What we heard report

Stage 1 public consultation: Draft Billabong Creek Floodplain Management Plan

March 2025

Figure 10: Refinements made to the proposed floodway network around Moulamein

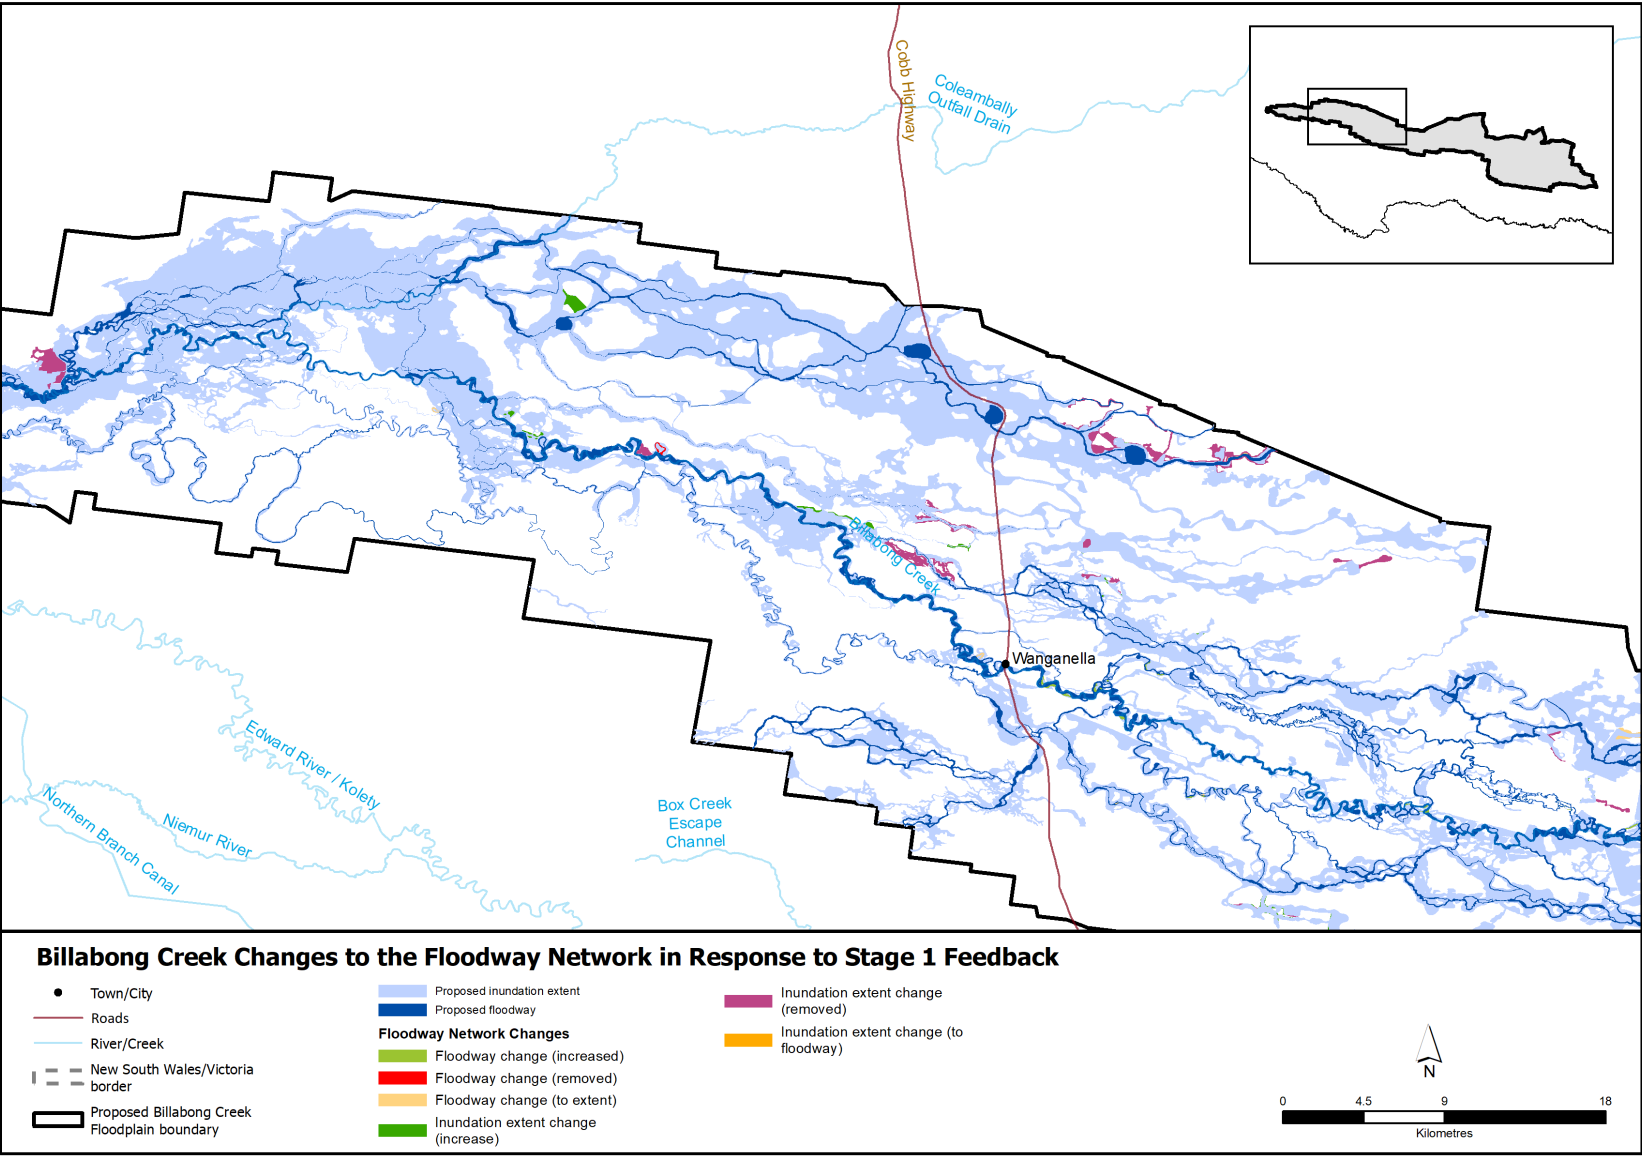
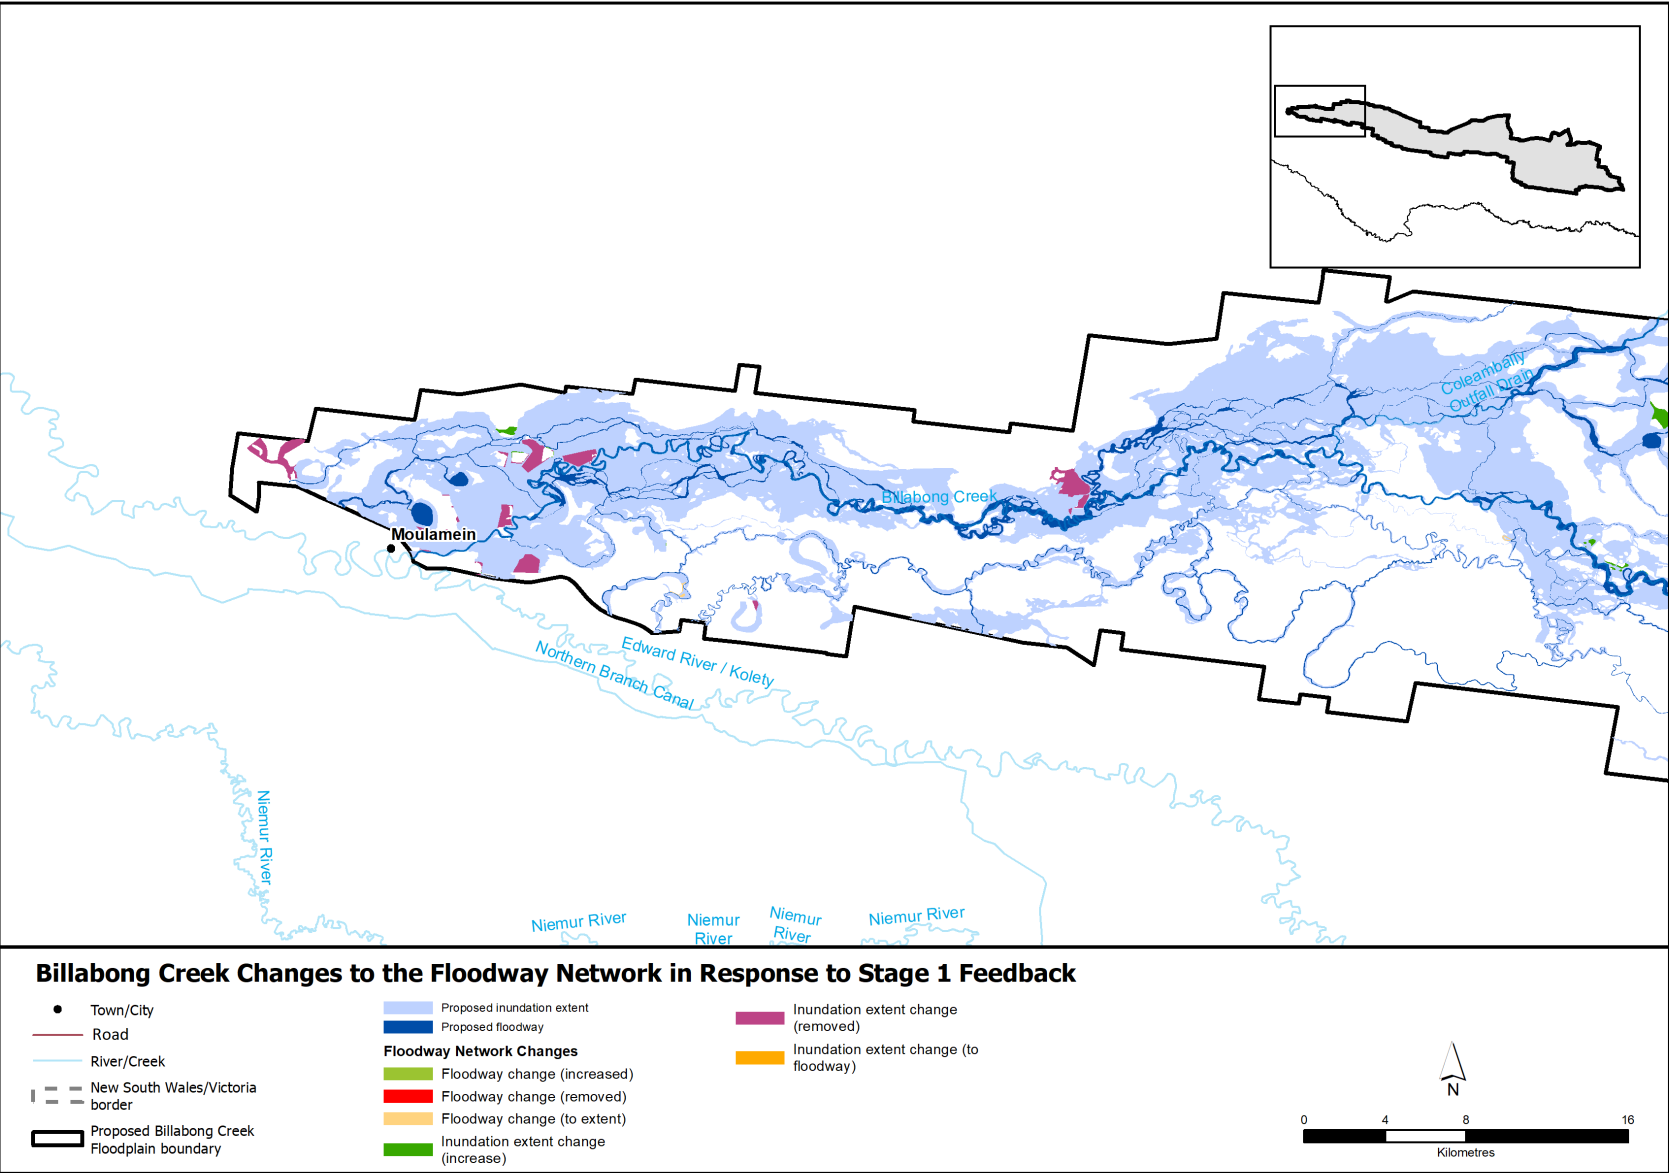
The proposed floodway network is incorrect in many areas as it covers areas that didn't flood in 2022. The 2012 flood should be used instead for modelling and mapping the floodway network.	The proposed floodways and inundation extent at some locations may differ from that experienced during flood events as they include a process for the consideration of unapproved flood works, as shown in Figure 8 in the <u>Report to assist Stage 1 public consultation</u>. In many instances, unapproved flood works will not be considered in the development of the floodway network. This results in some areas being shown as inundated due to the presence of an unapproved flood work preventing floodwater from moving into the area. The feedback received has resulted in multiple refinements being made to the proposed floodway network. These refinements are shown on Figures 5 to 10 in Appendix 3. Where proposed refinements related to unapproved flood works, no change was made.

Floodway does not match with river network showing on satellite image.	In response to this feedback, the department has reviewed the floodway across the proposed floodplain area against satellite imagery and realigned where needed. These refinements are shown on Figures 5 to 10 in Appendix 3.
The floodway looks accurate on the mapping.	Noted.

A summary of the feedback received is provided in Table 4. In response, the department has refined the proposed floodway network in multiple locations. These refinements are shown in Appendix 3. Where proposed refinements related to unapproved flood works, no change was made. An updated interactive spatial map will be published as part of Stage 2 public consultation of the draft FMP.
